SUNDRY NOTICES AND REPORTS ON WELLS
Do not use this form for proposals to drill or to re-enter an abandoned well. Use Form 3160-3 (APD) for such proposals.

EOG Resources Inc. (EOG) respectfully requests the execution of the variance for Wellhead break testing and offline cementing for the following wells, as outlined below (and with the additional Offline Cement Intermediate Operational Procedure):

Almost Eddy 30 Fed Com 500Hs

Revised Permit Information 03/23/2022:

Revised Wellbore

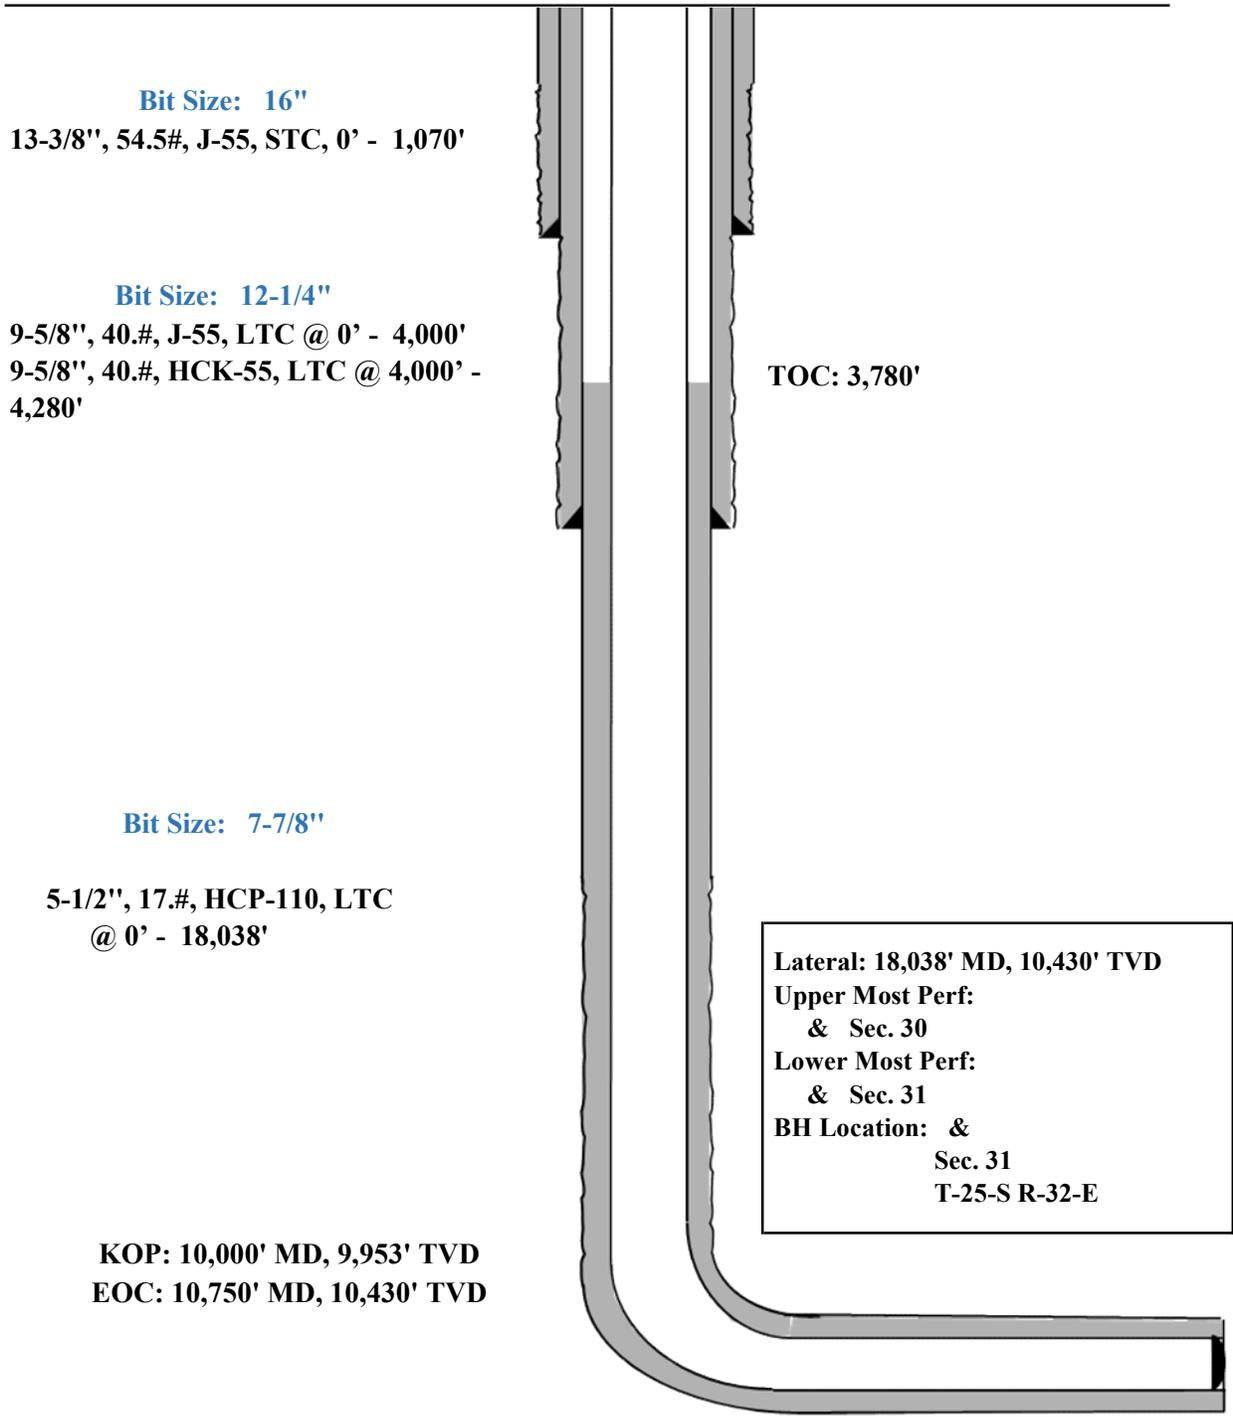
EOG respectfully requests to change the surface hole size from 17.5 to 16, and the production hole size from 8.75 by 8.5 to 7.875 (see attached casing design) for each well listed above.

Variance is requested to waive the centralizer requirements for the 9-5/8" casing in the 12-1/4" hole size. An expansion additive will be utilized, in the cement slurry, for the entire length of the 12-1/4" hole interval to maximize cement bond and zonal isolation.

Variance is also requested to waive any centralizer requirements for the 5-1/2" casing in the 7-7/8" hole size. An expansion additive will be utilized, in the cement slurry, for the entire length of the 7-7/8" hole interval to maximize cement bond and zonal isolation.

Bit Size: 16"

13-3/8", 54.5#, J-55, STC, 0' - 1,070'

Bit Size: 12-1/4"

9-5/8", 40.#, J-55, LTC @ 0' - 4,000'
9-5/8", 40.#, HCK-55, LTC @ 4,000' - 4,280'

Bit Size: 7-7/8"

5-1/2", 17.#, HCP-110, LTC
@ 0' - 18,038'

Figure 1: Cameron TA Plug and Offline Adapter Schematic

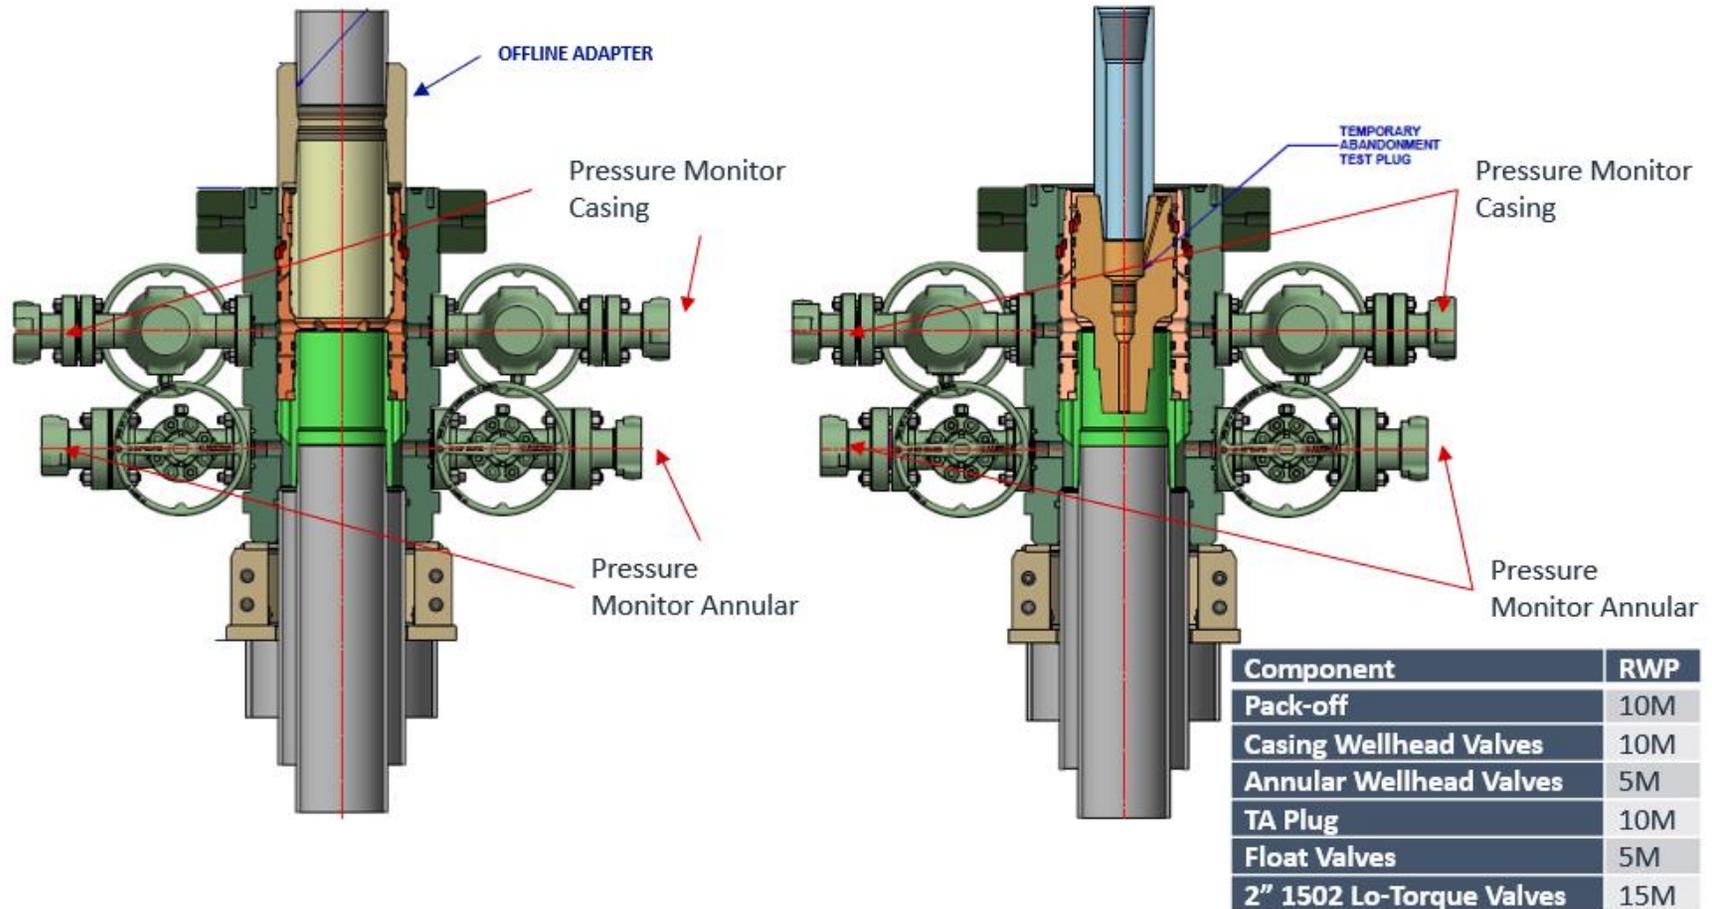
- c. Return line schematics can be seen in Figure 3.
10. Remove TA Plug from the casing.
11. Install offline cement tool.
 - a. Current offline cement tool schematics can be seen in Figure 1 (Cameron) and Figure 2 (Cactus).

Figure 4: Rig Placement Diagram

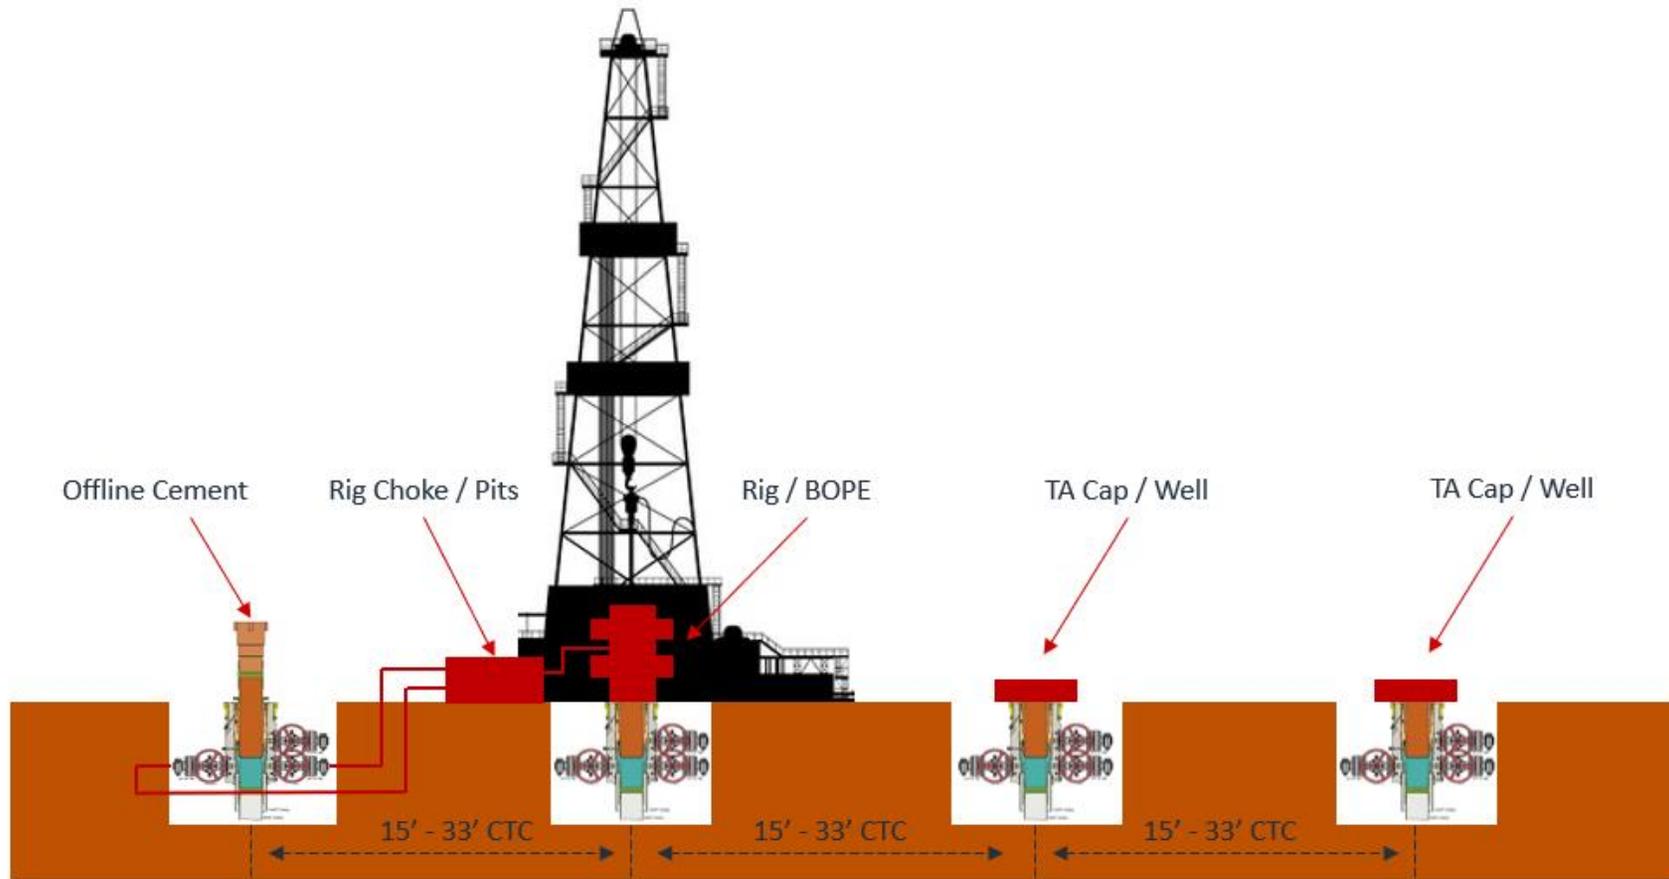
- e. Diagram for rig positioning relative to offline cementing can be seen in Figure 4.
9. Rig up return lines to take returns from wellhead to pits and rig choke.
